Didsbury Point

Non Material Amendments

Project name: Didsbury Point
Project number: 8845
Client: Southway Devco

Following recent approval of the Section 73. submission this document aims to pick up all remaining non material amendments made to the consented residential development; Didsbury Point (planning application ref. 135235/FO/2022), during the design development stage.

South Elevation

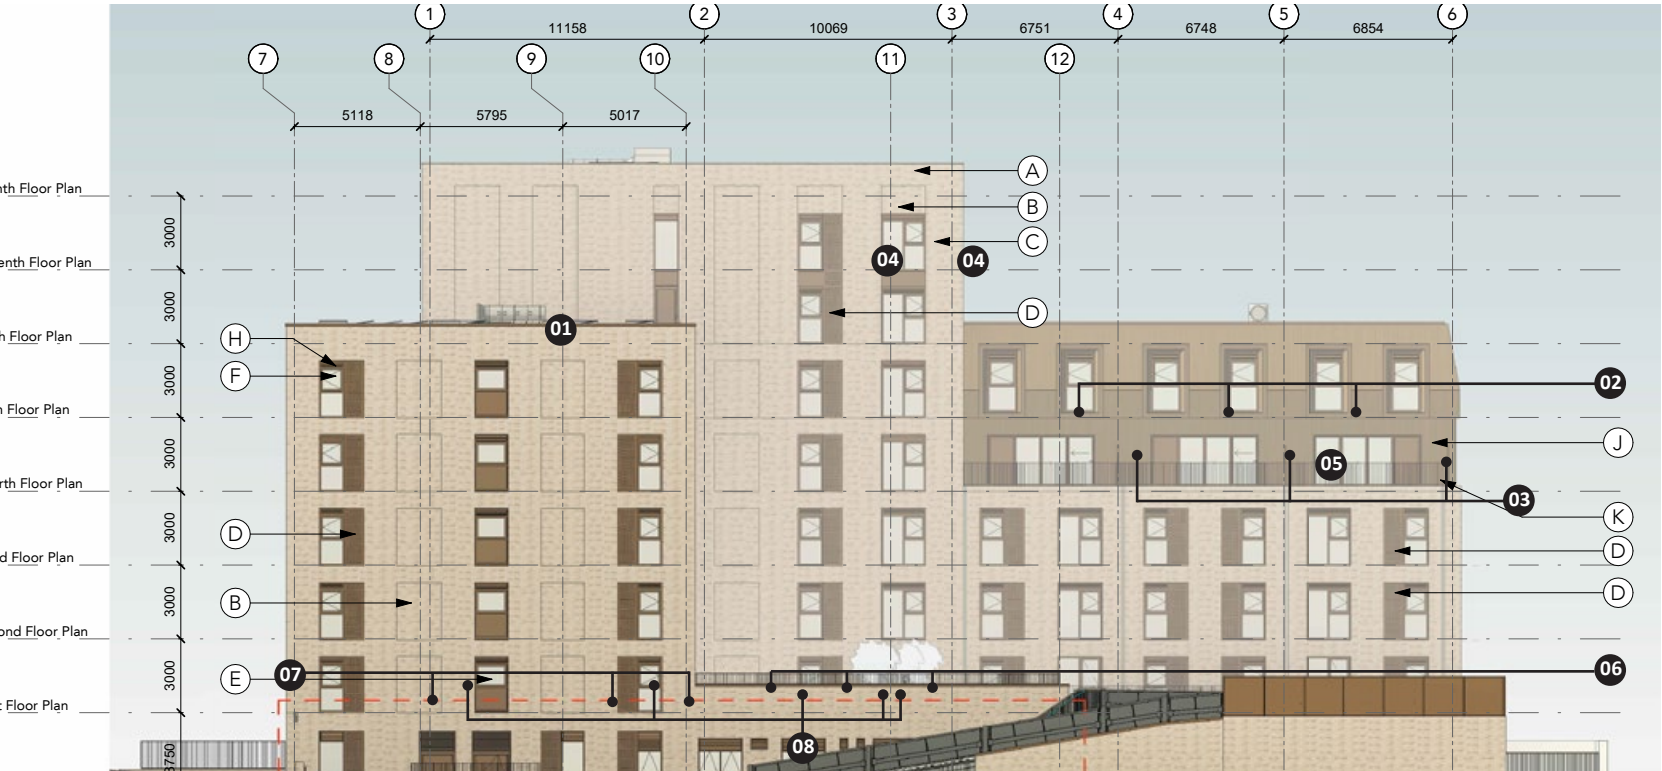
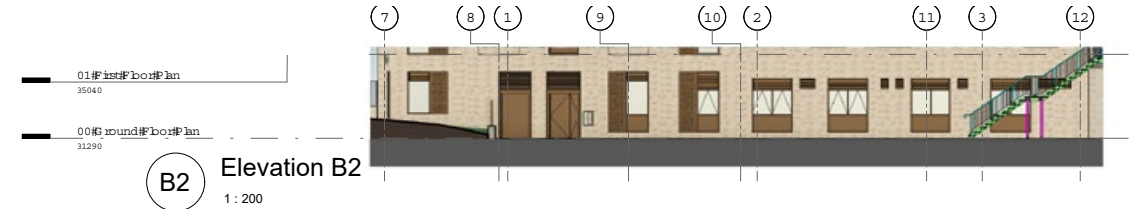
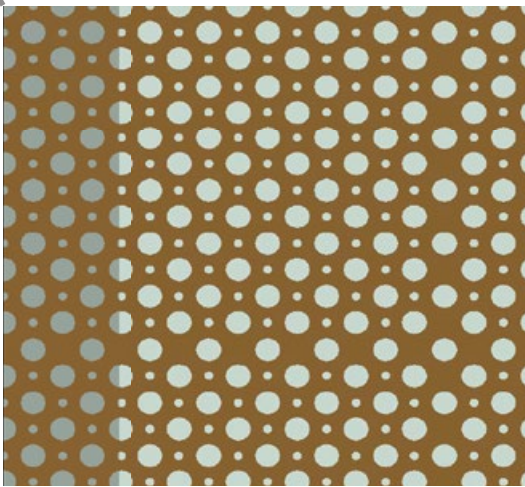
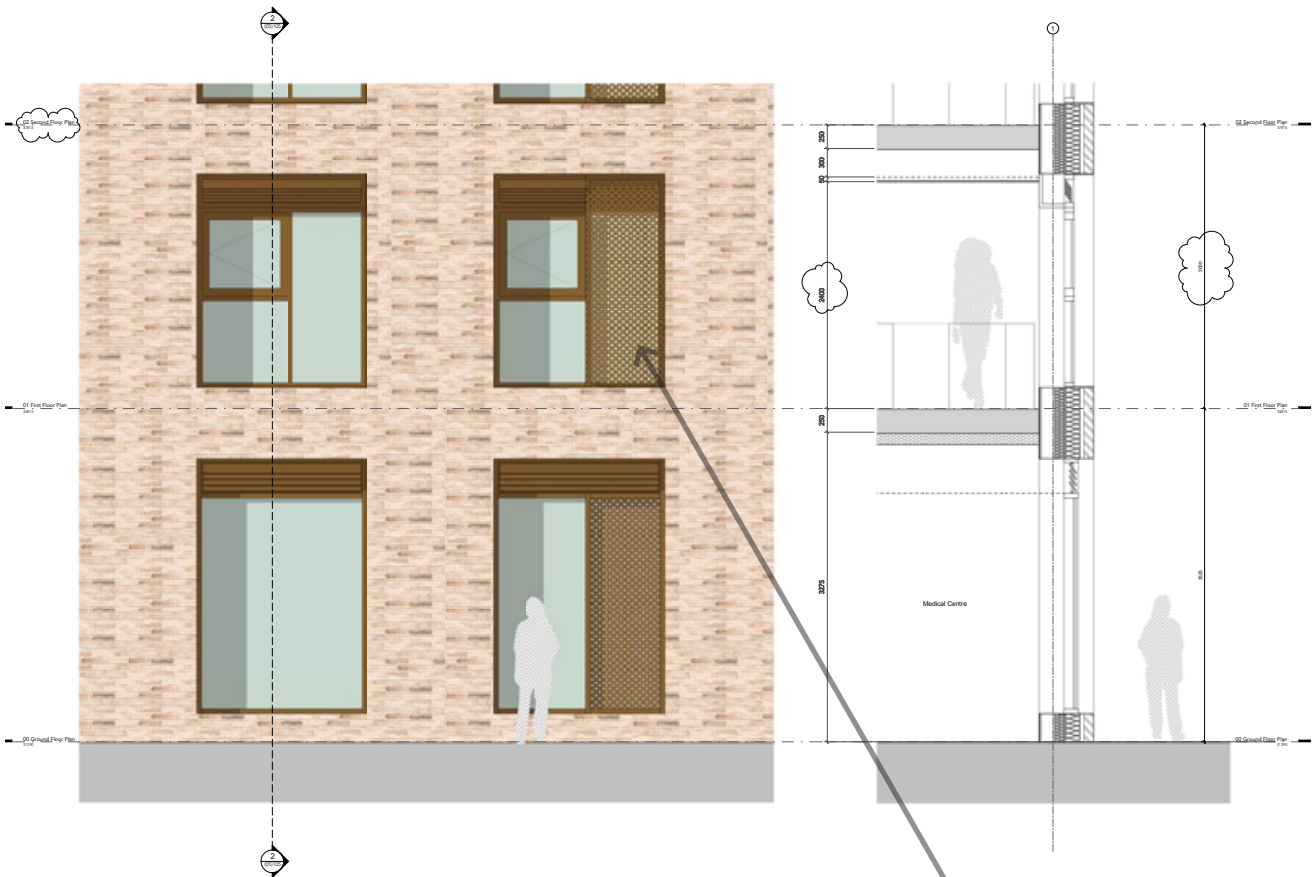
03. All window structural opening heights increased by 75mm and transom proportions altered to achieve height of 1100mm from FFL

05. Lower block heights increased by 225, 268 or 995mm

06. Position of ramp to car park altered.

01. Windows to staircore replaced with opaque glazed panel

02. Glazed screens updated to '4 panel' arrangement with integrated sliding patio door

03. Privacy screens added between and at end of duplexes at terrace level (x6 in total)

04. Joints to double height windows with perforated panel added. See 'Proposed Bay Study Sh. 2' for details

05. Windows in column mirrored

06. Curtain wall narrowed with addition of side panel

07. Additional medical centre louvres added

Proposed Bay Study Sh. 1

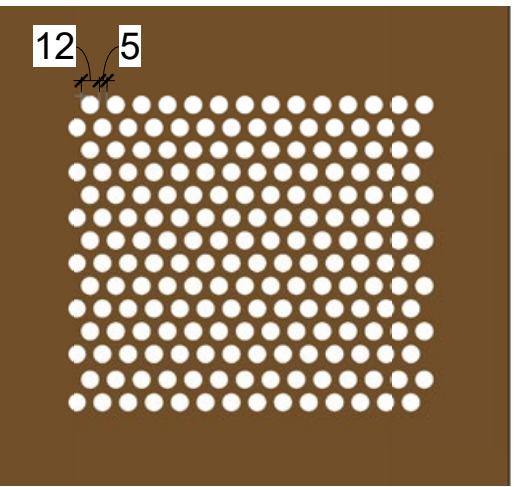
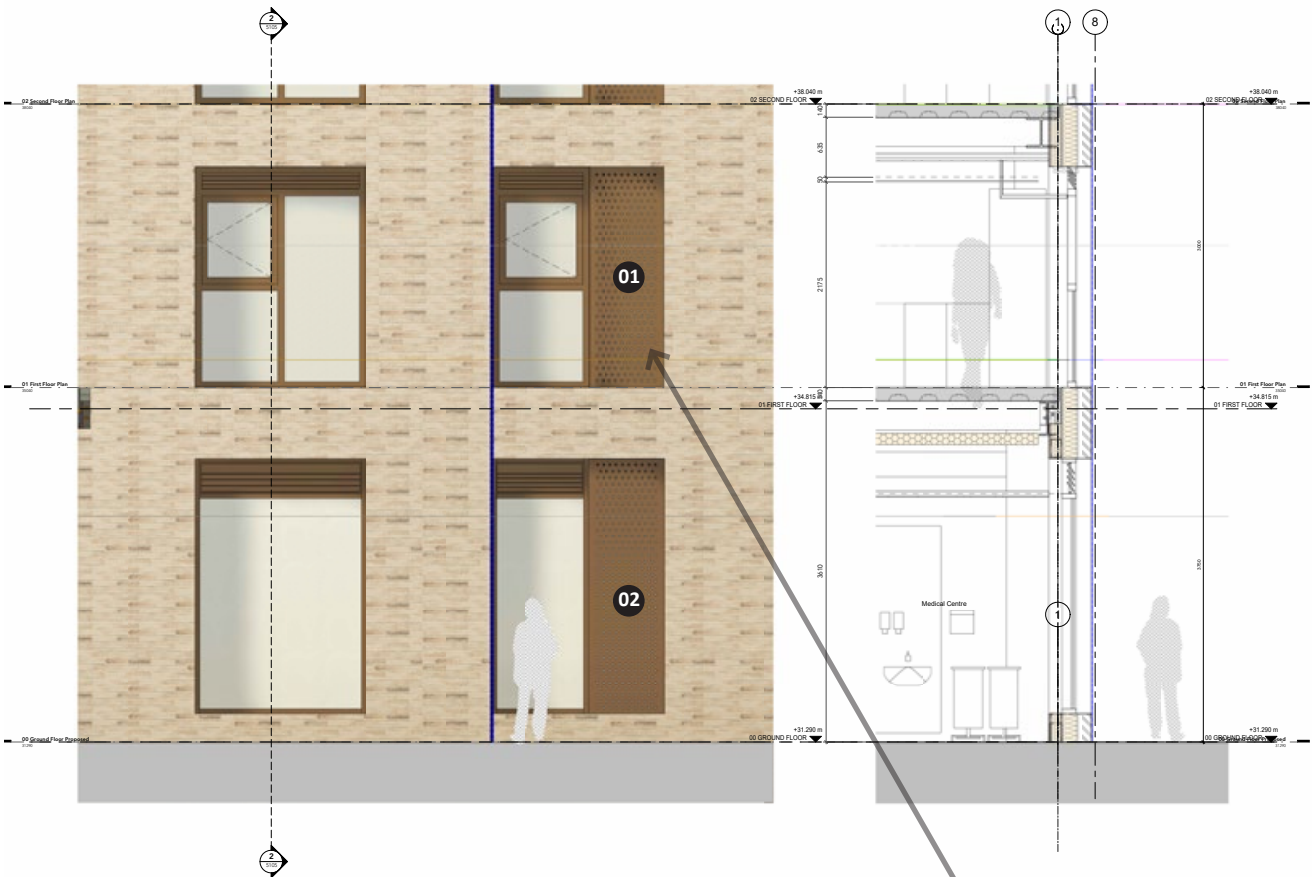
- 01. Change in proposed perforation pattern (12mm hole with 5mm separation distance)
- 02. Replacement of glazing with a solid panel
- 03. New design altered to include a border for fixings

Proposed Bay Study Sh. 2

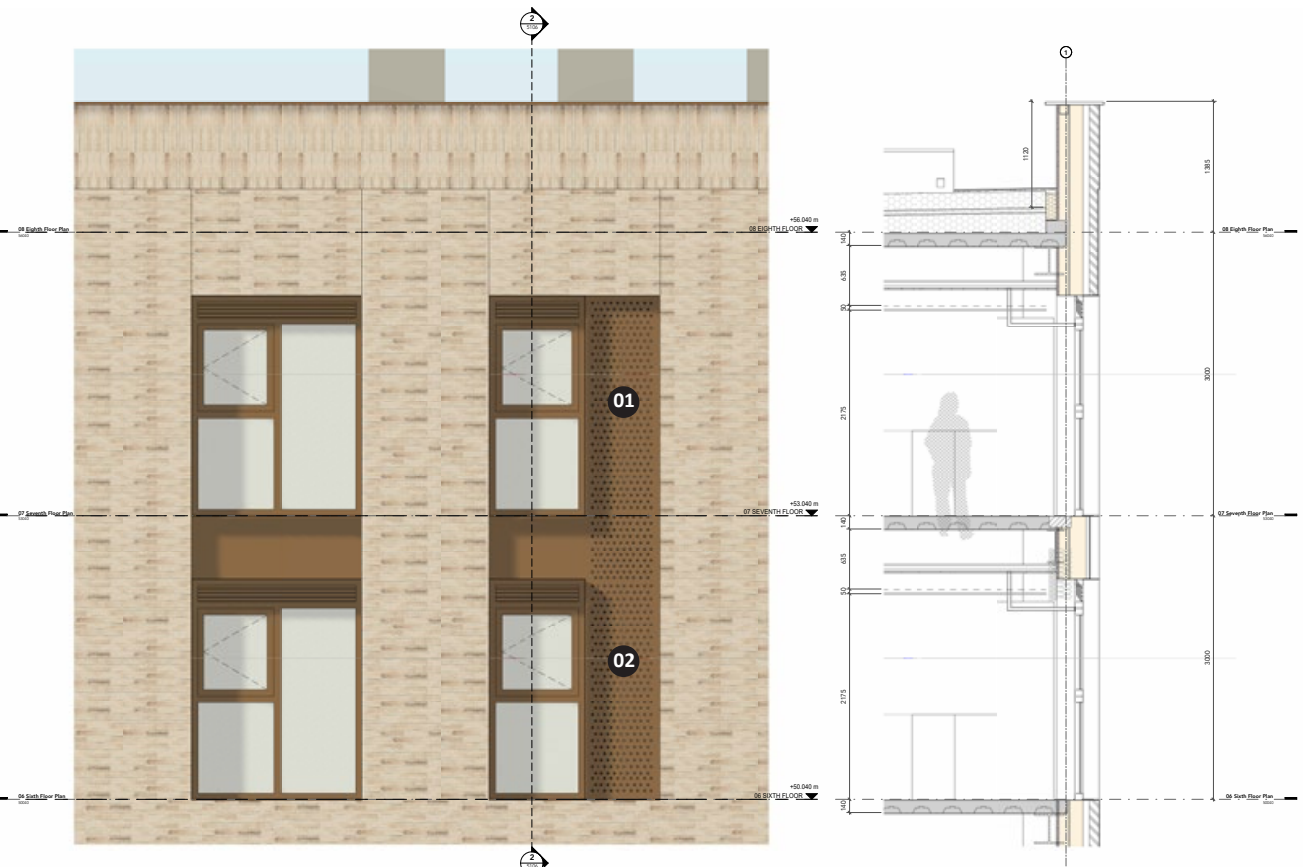
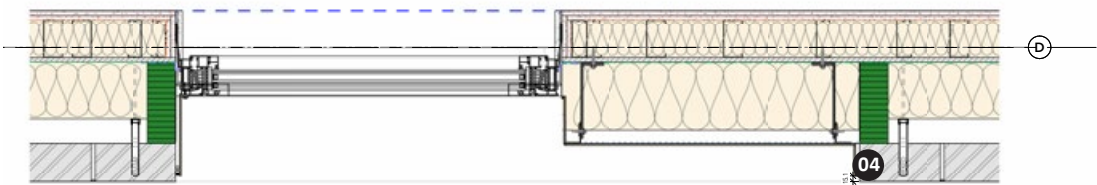
01. Change in proposed perforation pattern (see Bay Study Sh. 1)

02. Replacement of glazing with a solid panel (see plan detail to left)

The original intent was for glazing to sit behind a perforated screen however following a comprehensive access and maintenance review and overheating assessment at Stage 4, this glazing was omitted in favour of a continuation of insulation as shown in the plan detail (left).

The perforation design was further updated to align with the fixing rail position requirements as well as conforming to the maximum panel sizes available. On the double height panels, horizontal split lines were introduced at logical positions aligned with the head and base of the adjacent punched windows. These ensured the maximum sheet size could be accommodated whilst also giving the appearance a purposeful design language.

The final design iteration was to include a dark backing panel behind the perforated screen so as to conceal the insulation behind. Dark insulation was investigated as an option but discounted due to issues with certification around fire performance.

Ground Floor Plan

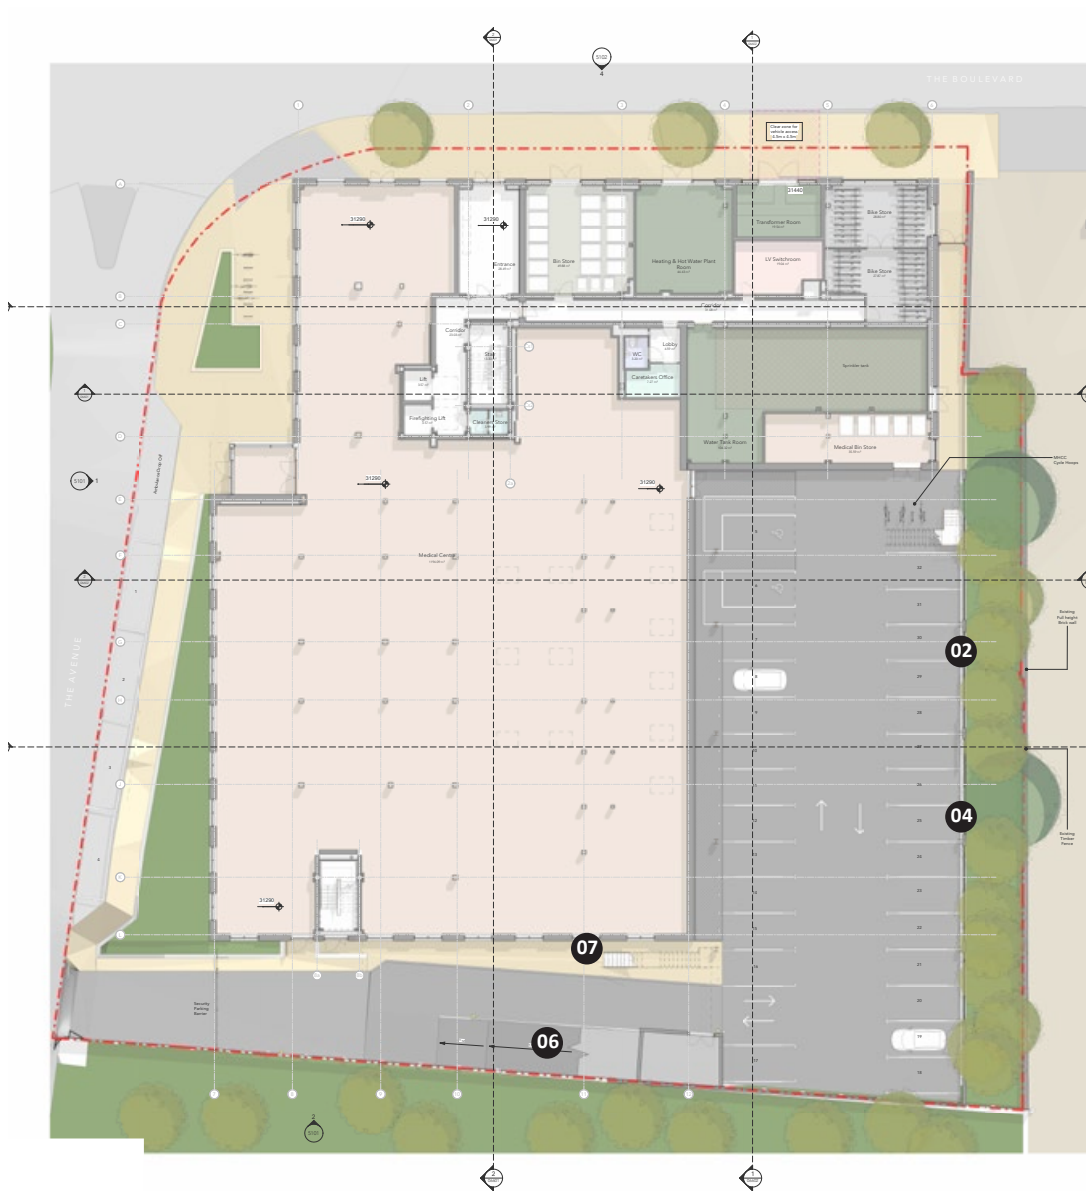
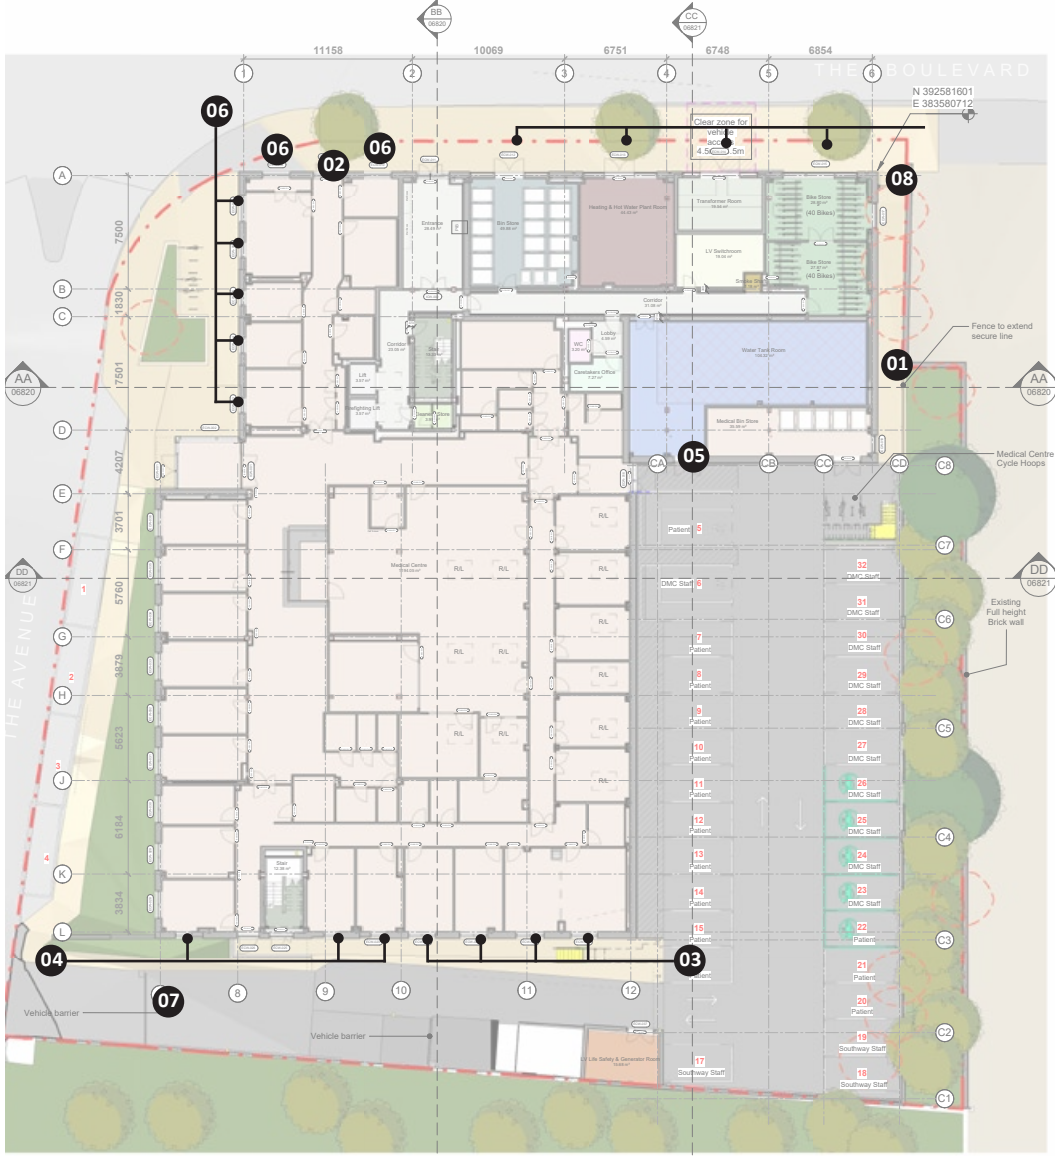
- 02. Car park podium materiality changed to alternating louvred screens and brick piers
- 04. Car park green wall removed
- 06. Position of ramp to car park altered.
- 07. Changes to louvred screens to ground floor

- 01. Bin store relocated so door removed
- 02. Medical centre entrance / exit altered
- 03. Louvres above windows removed
- 04. Curtain wall narrowed with addition of side panel
- 05. Additional double doorset
- 06. Areas of obscure glazing to medical centre
- 07. Pedestrian gate omitted following recommendation from SBD officer. Vehicular barrier relocated further east to improve access to car park and control of access and egress.
- 08. Gate to east boundary moved towards northern elevation building edge

Typical Level 01 - 03 Floor Plan

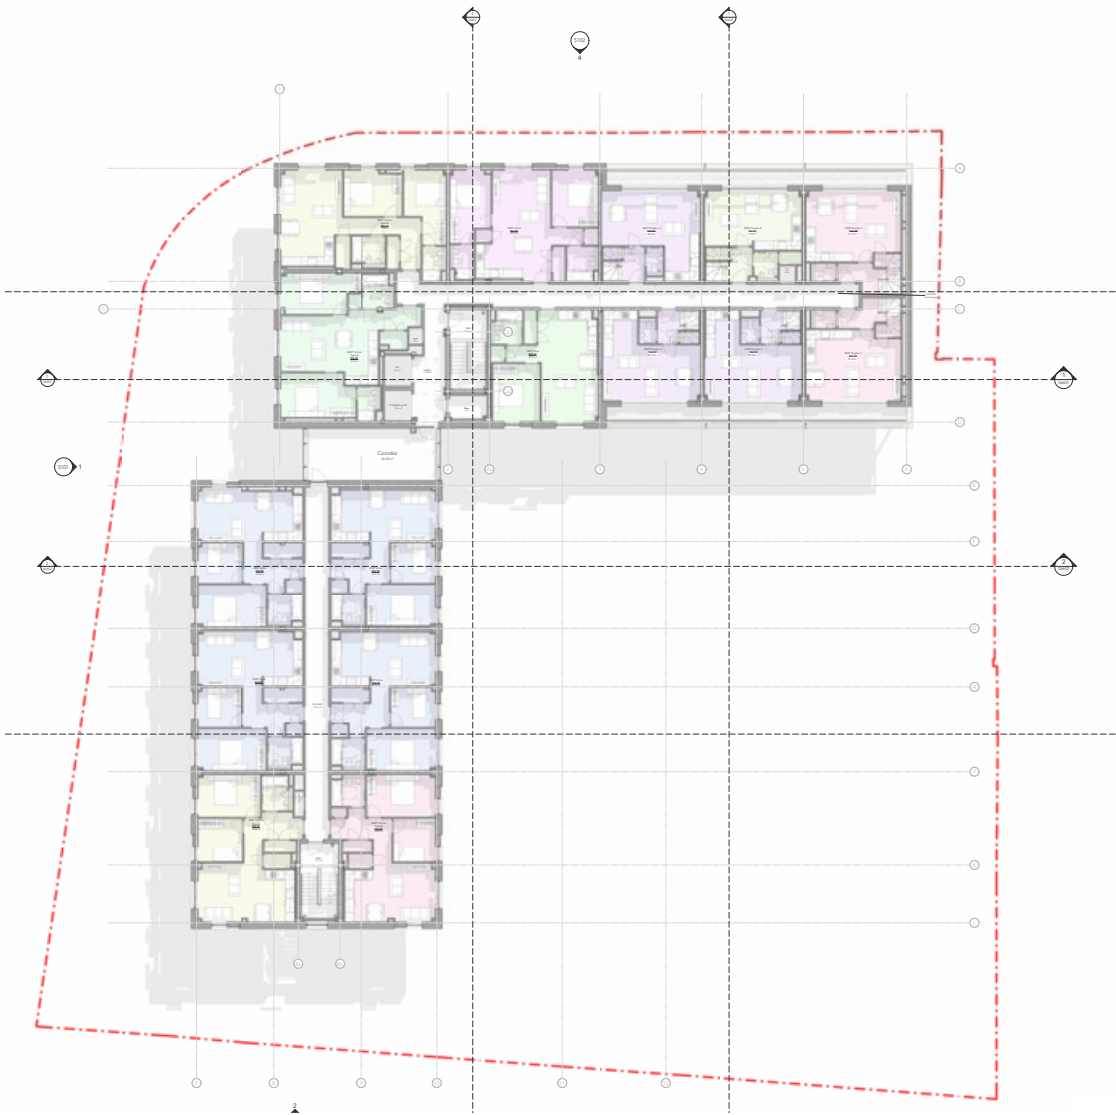
02. Car park podium materiality changed to alternating louvred screens and brick piers

04. Car park green wall removed

06. Position of ramp to car park altered.

- 01. Windows to staircore replaced with opaque glazed panel
- 02. Windows to have obscure glazing
- 03. Window (& perforated panel) in column mirrored
- 04. Change to apartment areas (refer to detailed page on updates and rationale).
